Technical Service Information

THM 4L80-E/4L80-EHD PUMP BODY AND PUMP COVER IDENTIFICATION FOR SERVICE

Figure 1

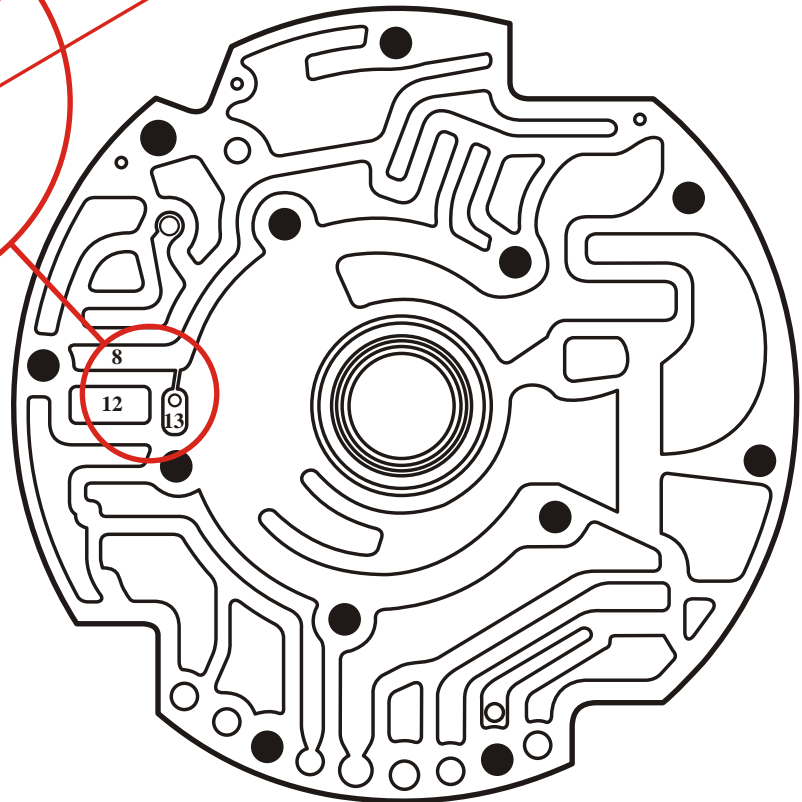
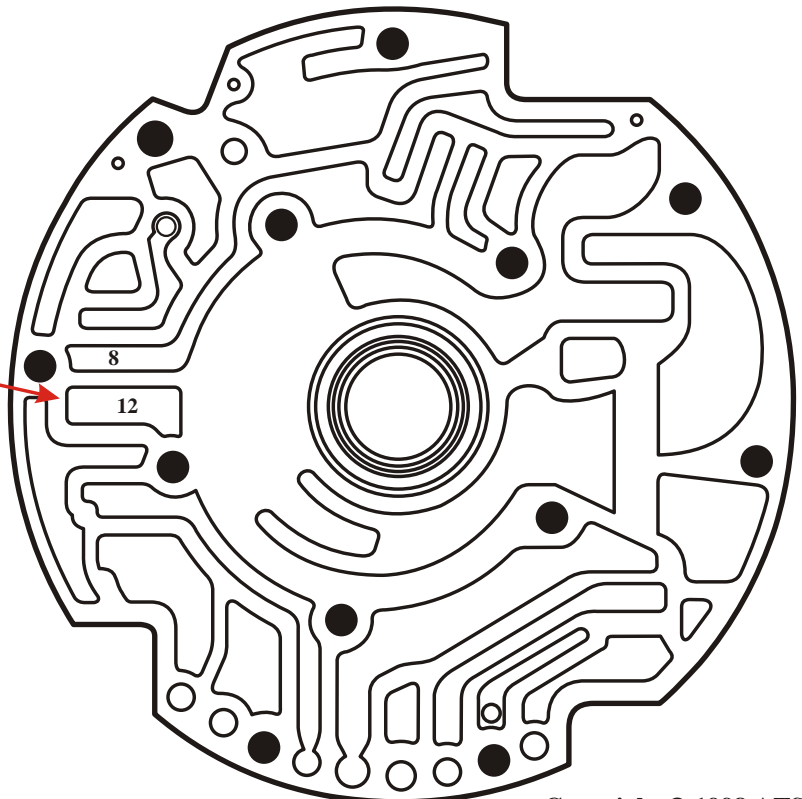
- (1) OIL PUMP COVER - 1997-Up models ***will*** have the slot machined between the pump cover passages and there ***will*** be a hole drilled in the number 13 cavity, as shown in the top illustration in Figure 1. The 1991-1996 pump cover, part number 24205398, will not have the slot machined and ***no hole drilled*** in cavity 13, as illustrated in Figure 2. However, we have seen one 91-96 oil pump cover for service that had the slot machined but no hole drilled in cavity 13, which is still okay to use.
- (2) OIL PUMP BODY AND GEARS - One pump body, part number 24211287, will back service all models of the THM 4L80-E/4L80-EHD transmission and is illustrated in Figure 3.

Lube Hole is drilled and the slot must be cut into casting.

**NEW DESIGN PUMP COVER TO
SERVICE 1997-UP MODELS ONLY**
Part Number 24204303
